**Subject:** San Mateo Park Elementary School HVAC Replacement  
San Mateo - Foster City School District  
Aedis Project No. 2021011.08  
DSA Application #01-120214

### ADDENDUM NO. 1

San Mateo Park Elementary School HVAC Replacement  
San Mateo – Foster City School District  
Aedis Project No. 2021011.08

4 WALL MOUNT SPLIT SYSTEM CONTROL SCHEMATIC

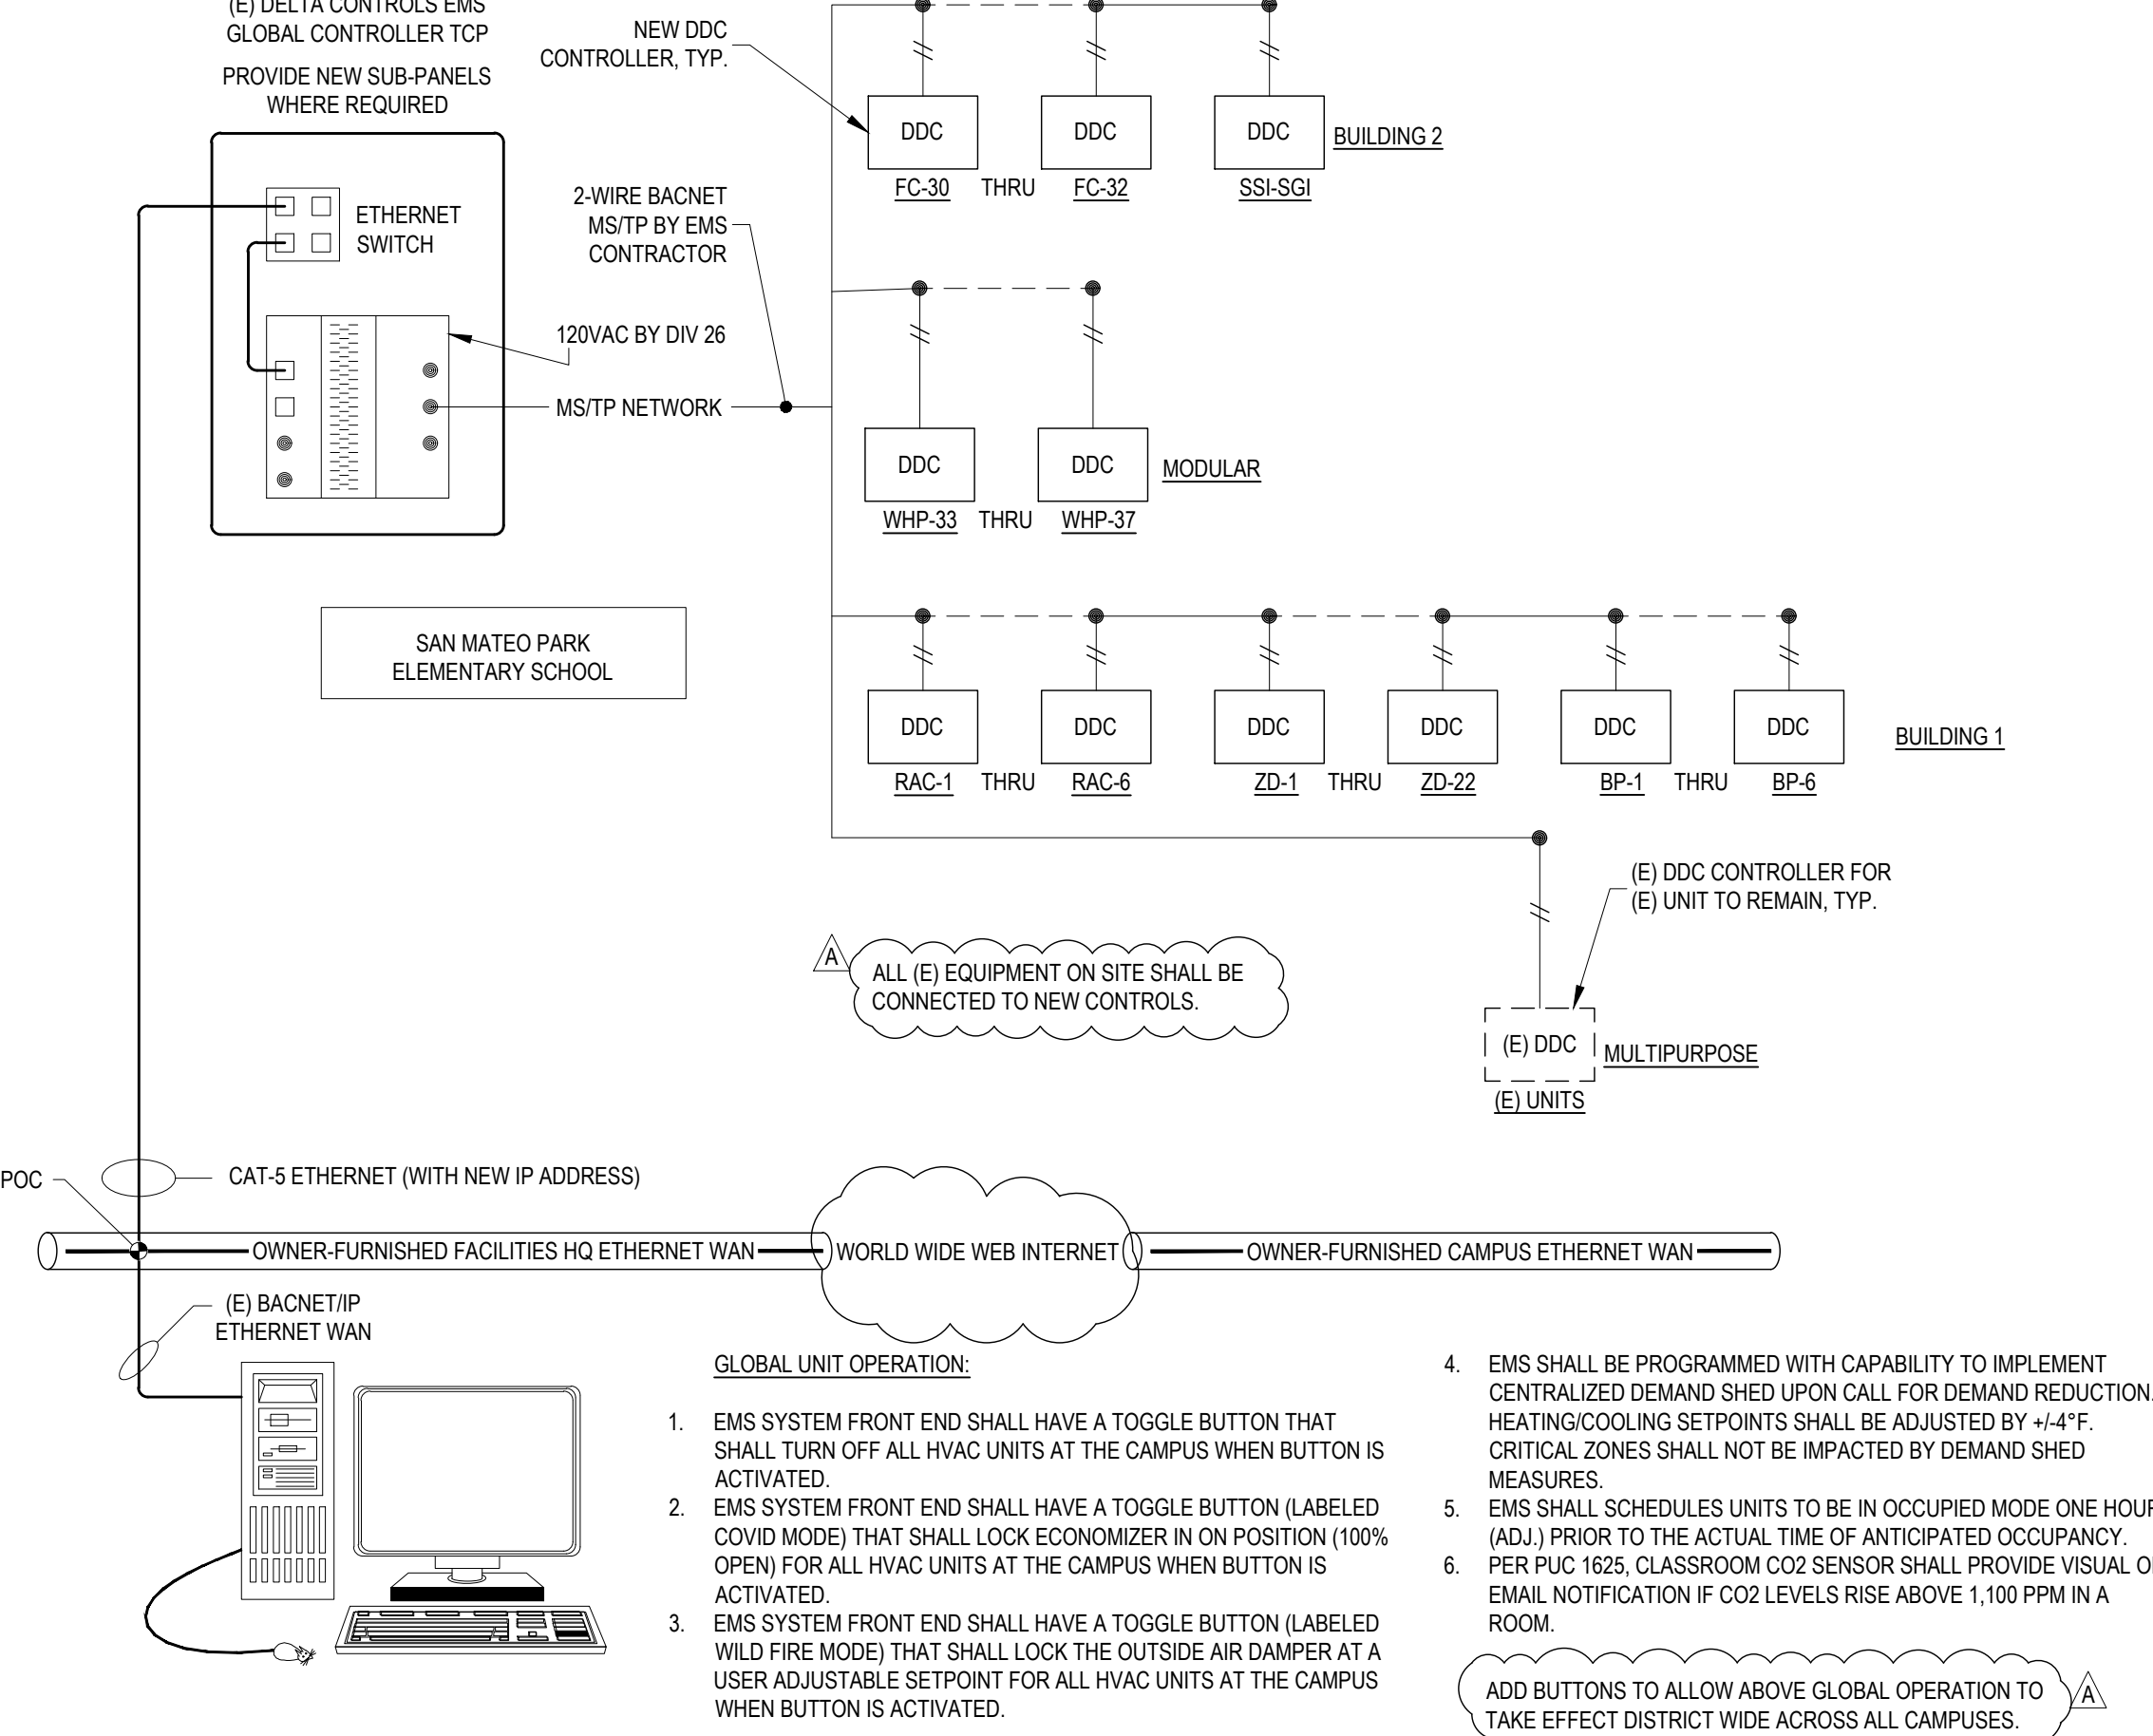
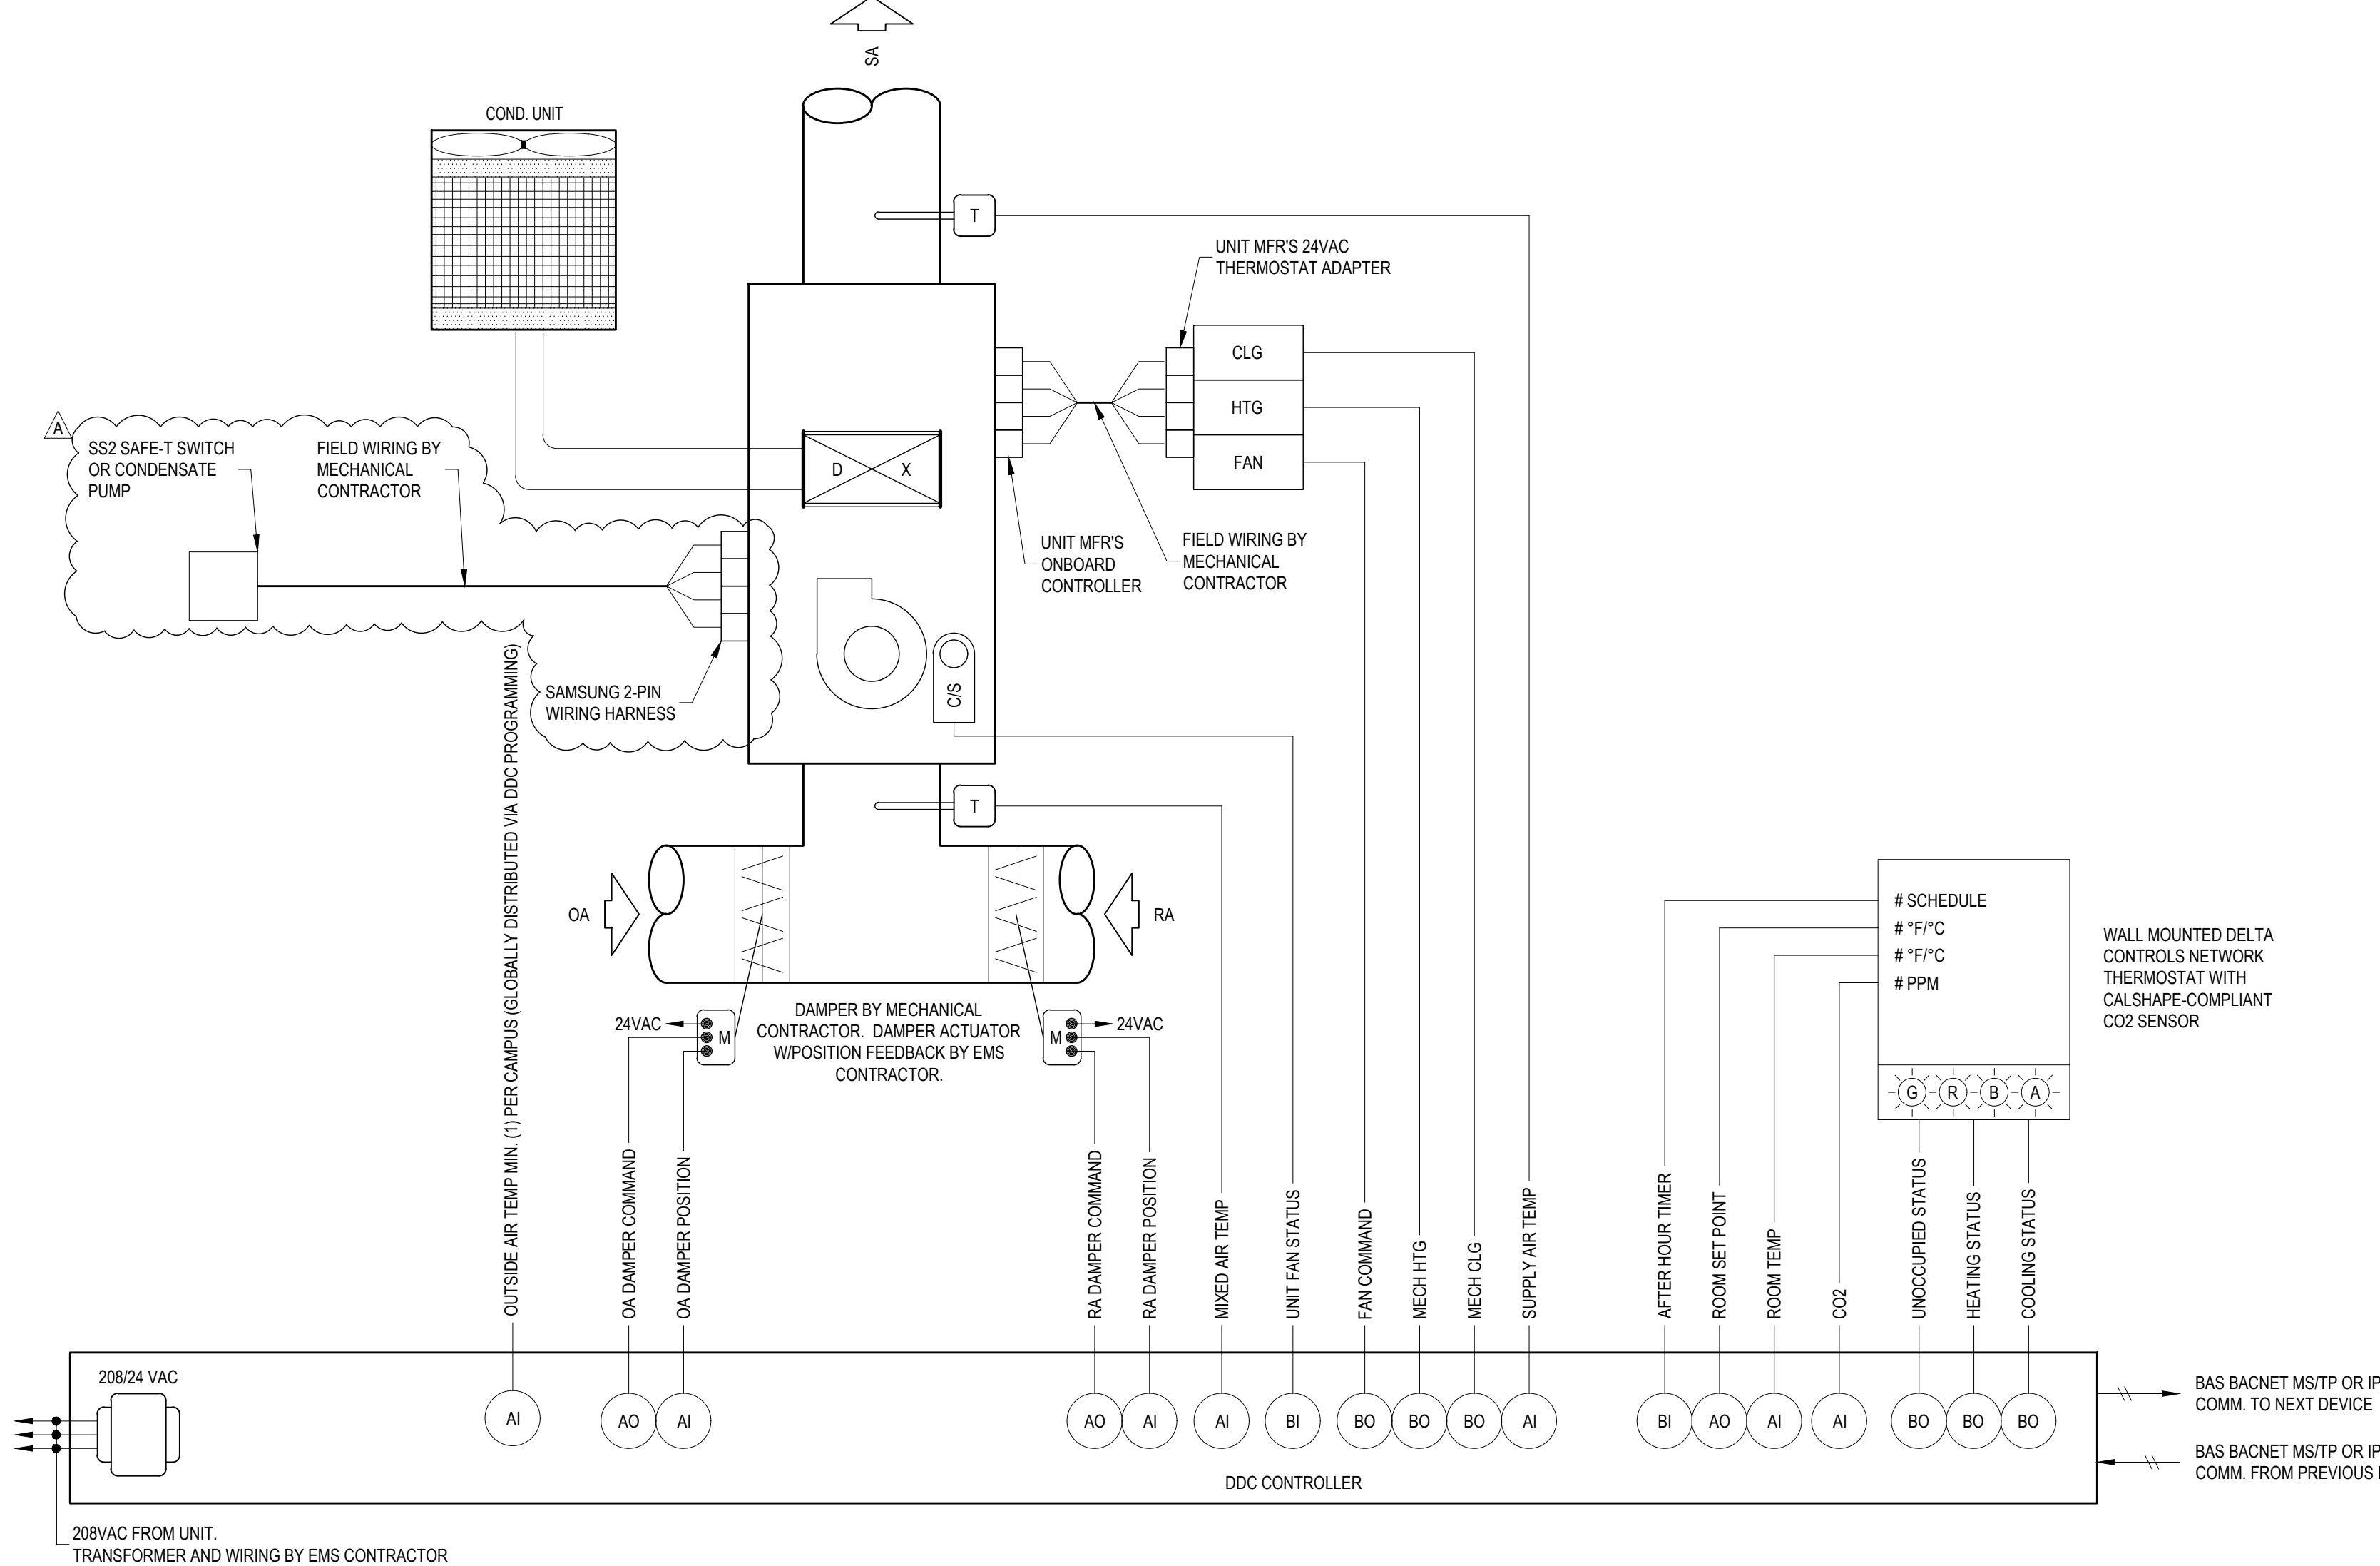
Add: New notes to EMS System Architecture as shown per AD1-MP5.01

Revise: Sequence of operation numbering at Classroom Split System Heat Pump/Fan Coil Unit Control Schematic as shown per AD1-MP5.01

Add: Sequence of operation note #12 and wiring for condensate pump overflow protection to Classroom Split System Heat Pump/Fan Coil Unit Control Schematic as shown per AD1-MP5.01

Add: Sequence of operation note #8 and wiring for condensate pump overflow protection to Wall Mount Split System Control Schematic as shown per AD1-MP5.01

Add: Packaged AC Unit Control Schematic Note #14 and wiring for power exhaust as shown per AD1-MP5.01

Revise: Packaged AC Unit Control Schematic Notes #8 & #9 as shown per AD1-MP5.01
